BRIEFING SUMMARY SHEET

DEVELOPMENT ASSESSMENT CASE NUMBER: CD-2025-0001

Presentation of a Development Assessment Report for 600 E. Riverside Planned Unit Development (PUD), located at 600 and 600 ½ East Riverside Drive, within the Lady Bird Lake Watershed in District 9.

The staff's comments on the applicant's Development Assessment submittal for this proposed PUD project are compiled in the Staff Comments Report for case CD-2025-0001 (see Master Report – Exhibit F).

EXISTING IMPERVIOUS
COVER EXH

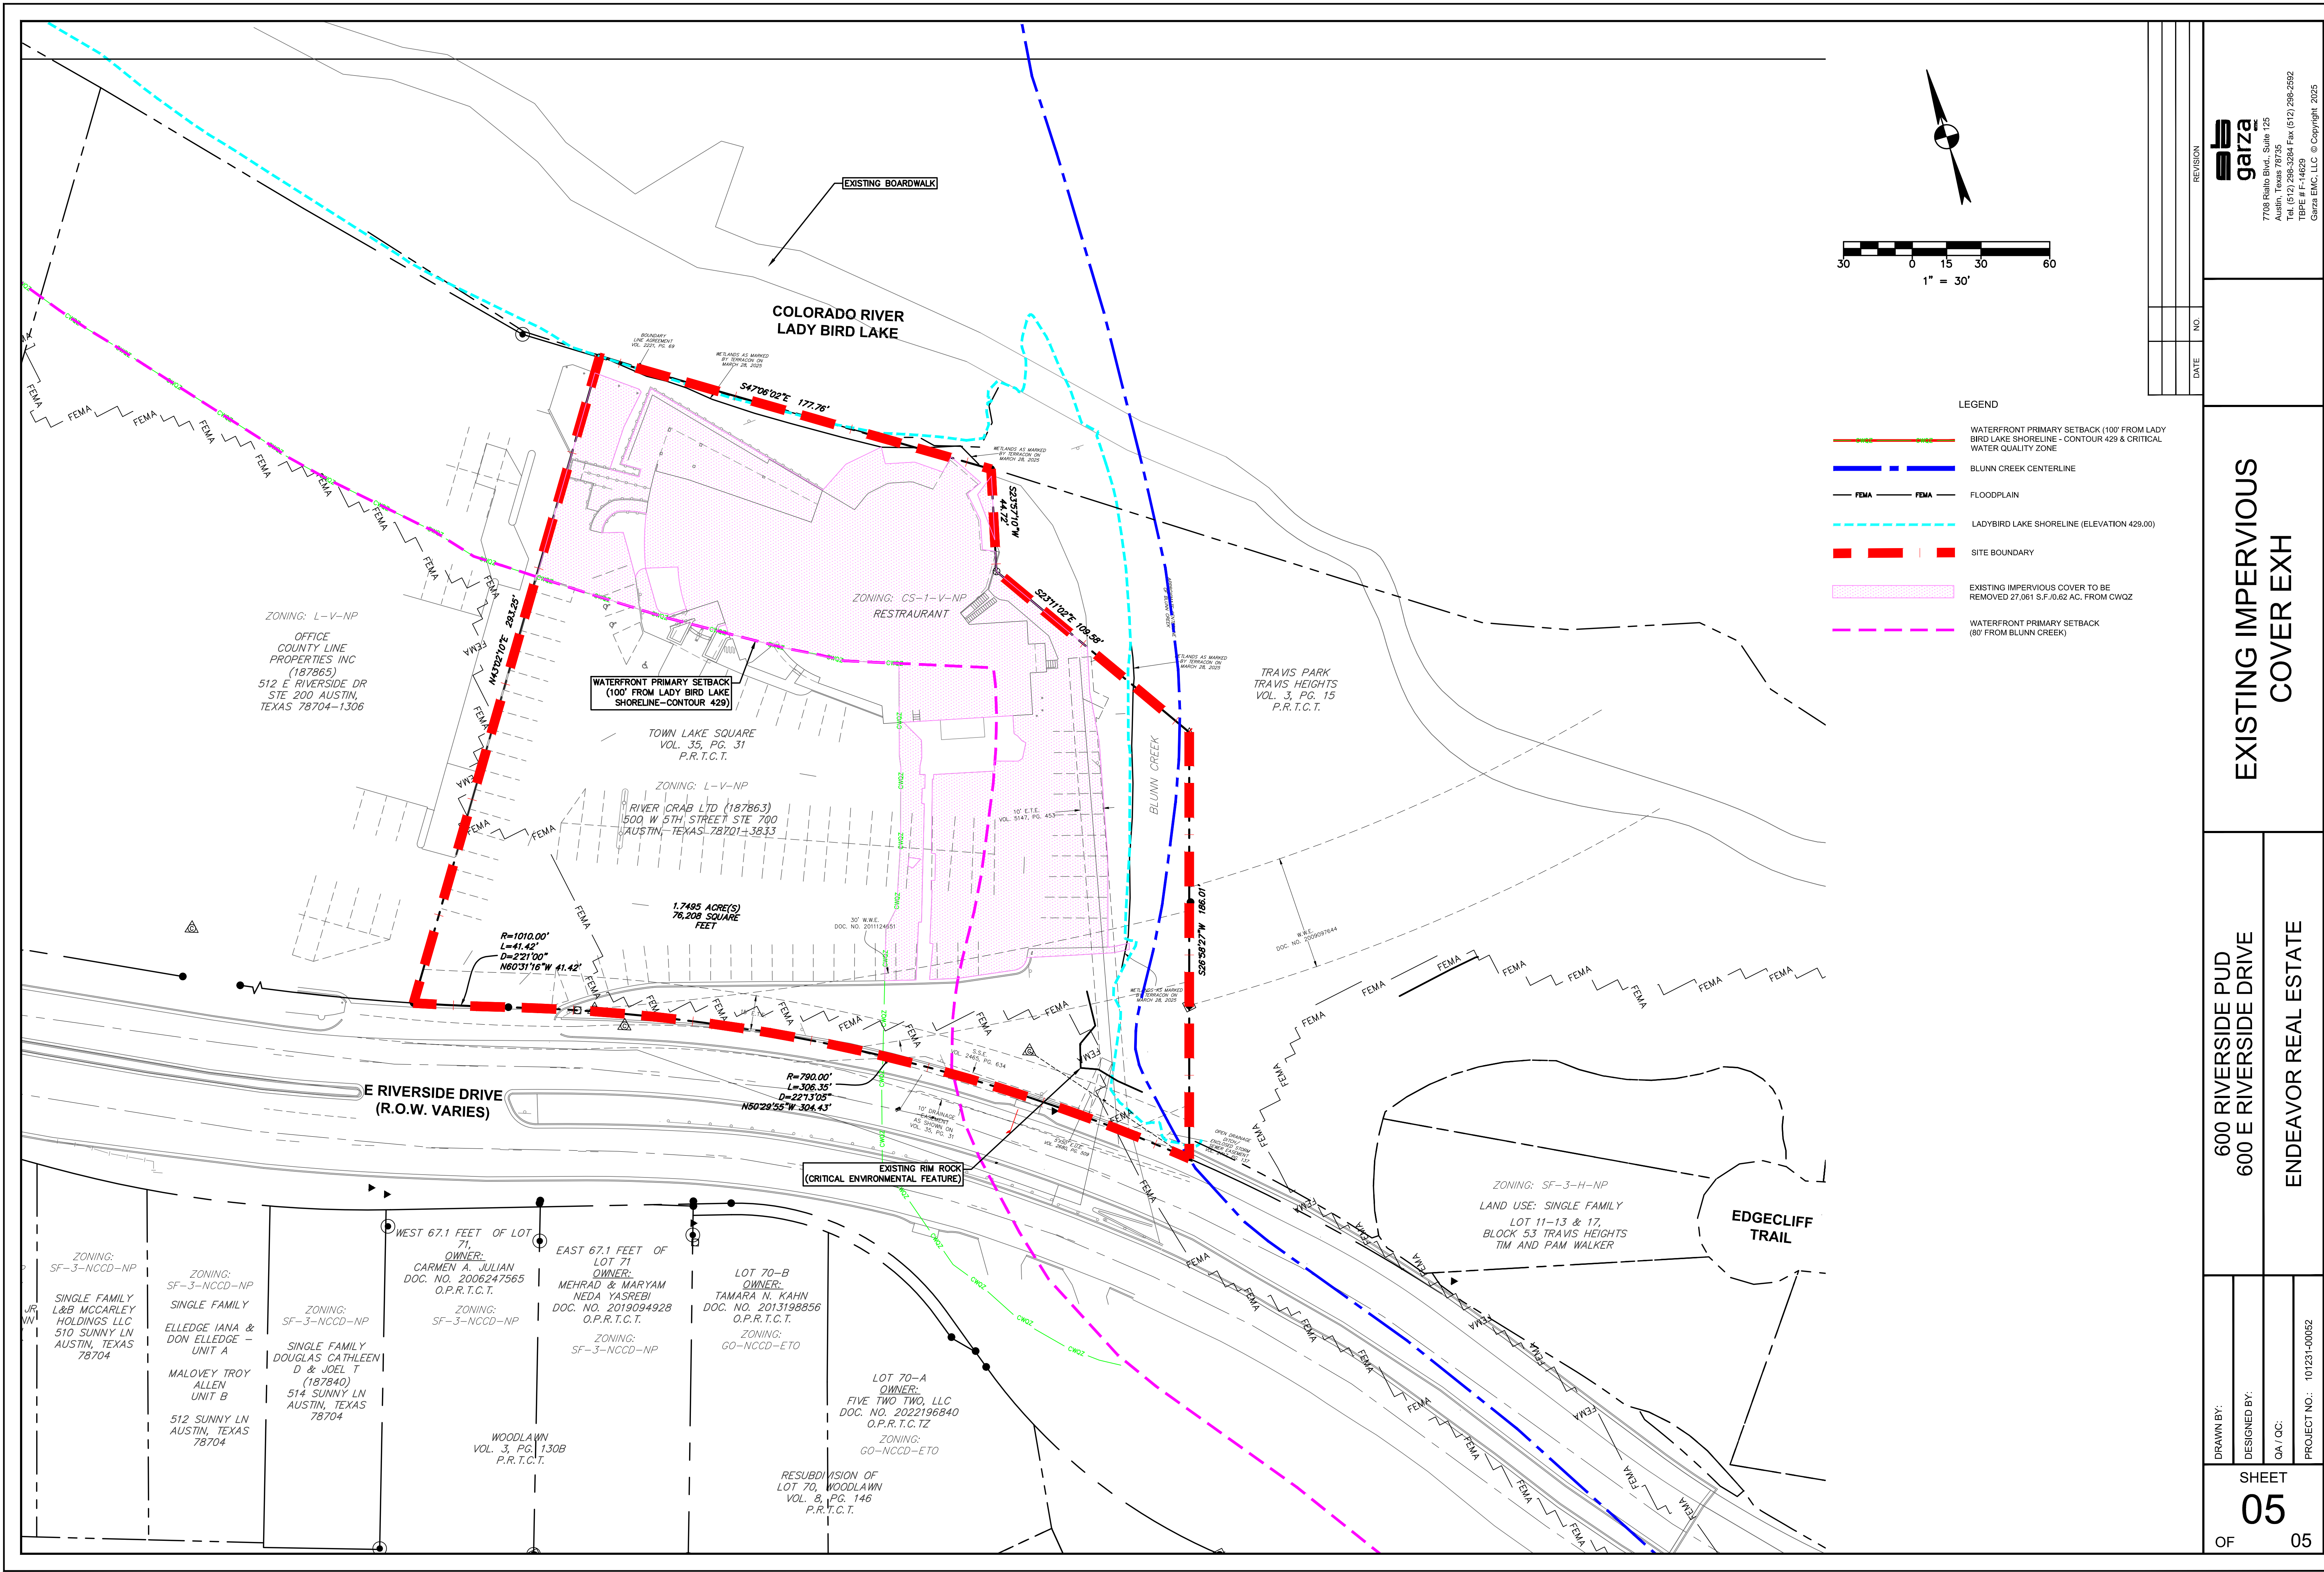
Provide a conceptual exhibit showing the locations and extent of development proposed within the CWQZ. Staff support the removal of all impervious cover from the inner CWQZ.

Recommend adjusting the linework of R-2 to be consistent with the surveyed topography in the Land Use Plan.

Discharge of stormwater from biofiltration/raingarden/detention areas should be directed away from R-2 and Blunn Creek as sheet-flow and not as a point discharge where possible.
